2500 N. HOLLYWOOD WAY – DUAL BRAND HOTEL PROJECT

FINAL ENVIRONMENTAL IMPACT REPORT

2500 N. Hollywood Way – Dual Brand Hotel Project Final Environmental Impact Report

X03 NO.	DRAWING NO.
	DR2.2
NEW SITE PLAN	DATE: 02/29/2004

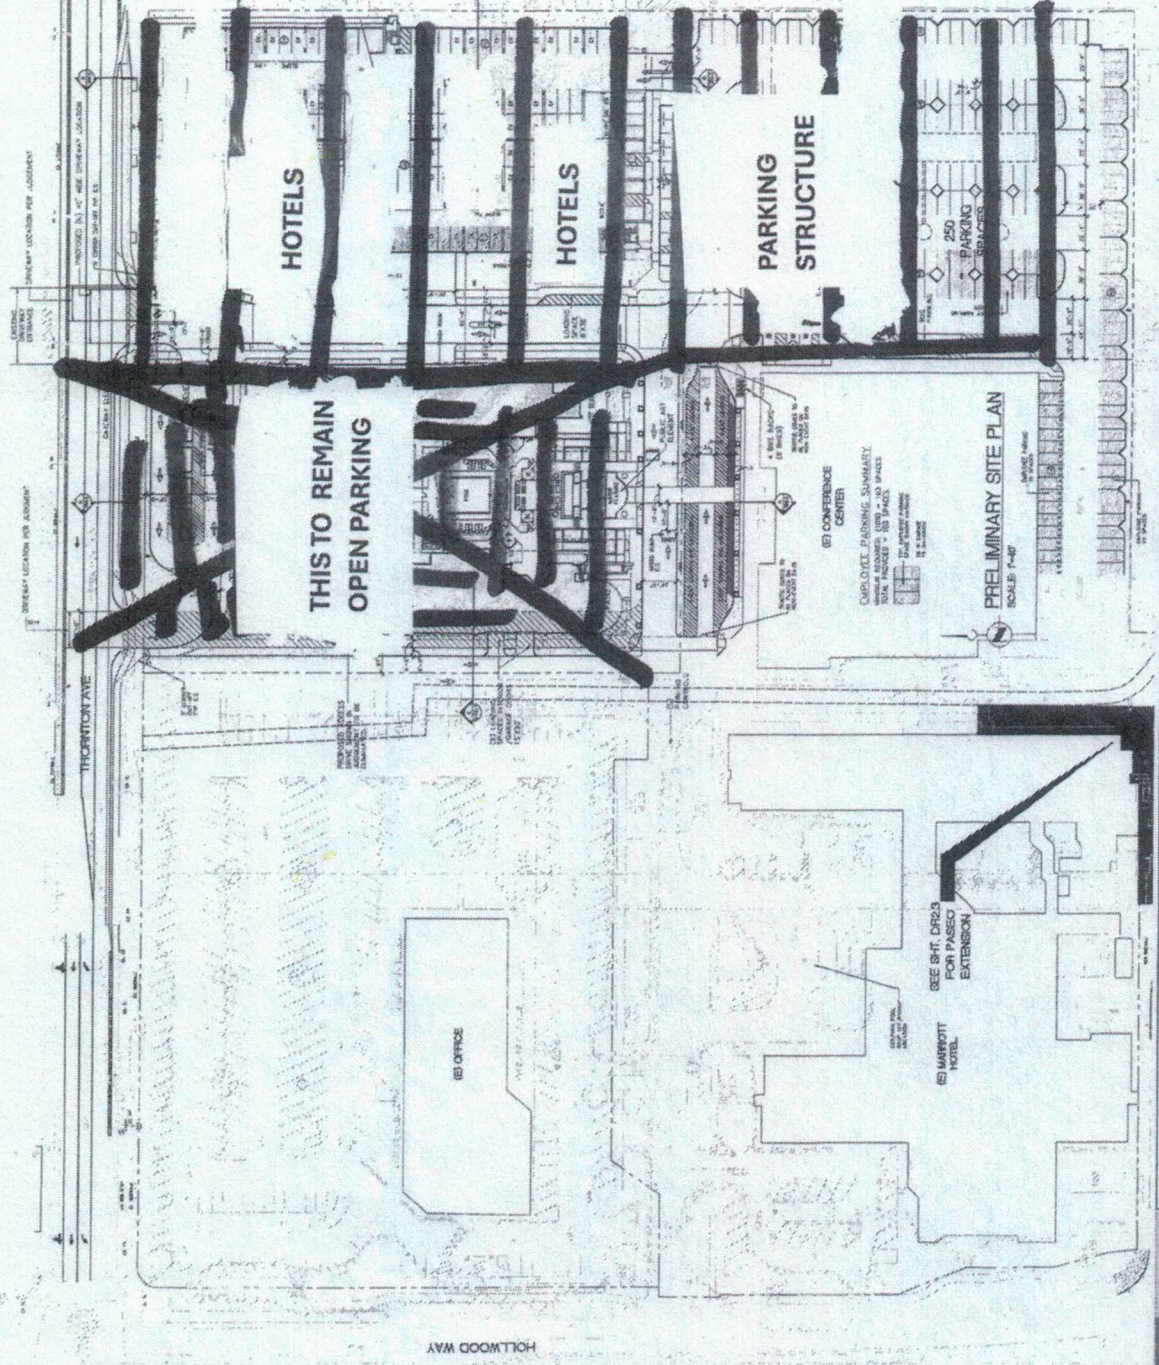
Relocating the 2 [proposed] Hotels and Parking Structure, as set forth above, would result in a far superior Project as it would mitigate many of the concerns and objections of the Office Parcel. I attach hereto a site plan taken from the DEIR where I have outlined the area the Office Parcel believes must be studied and approved. I believe the area I have outlined has approximately the same land area as is the currently proposed Project.

The comments reference the Draft EIR Project Alternatives and identifies the commenters preference for consideration of an alternative site layout (included as an exhibit to the comment letter) wherein the Hotel and Garage are sited to the east of the existing convention center to provide a farther distance from the Office building owned by SHG LLC when compared to the currently proposed location within the Project site. The commenter also incorrectly asserts that the alternative site layout “must be studied as a Project Alternative and legally sufficient reasons must be provided if the alternative of relocating...is not approved by the City and the Applicant.”

Furthermore, the proposed Project could not be relocated directly east of the convention center, as the commenter suggests, because the proposed Hotel would not fit in that space, which is too narrow to accommodate the proposed footprint. Refer to the figure included at the end of the responses to this comment letter. The site is also not deep enough to accommodate the proposed Hotel and Garage to be situated end-to-end north to south from Thornton Avenue to the parcel's south property line. Moving the Hotel away from Thornton Avenue would have the potential to adversely impact traffic circulation within the site as the valet would not be right at the driveway, forcing all drop-offs to venture farther into the site, in addition to circulation issues caused by locating the Hotel drop-off farther from the street than the Garage. Therefore, the proposed location of the Hotel and Garage is the only option with enough space to accommodate the proposed Hotel footprint and avoid circulation issues within the site.
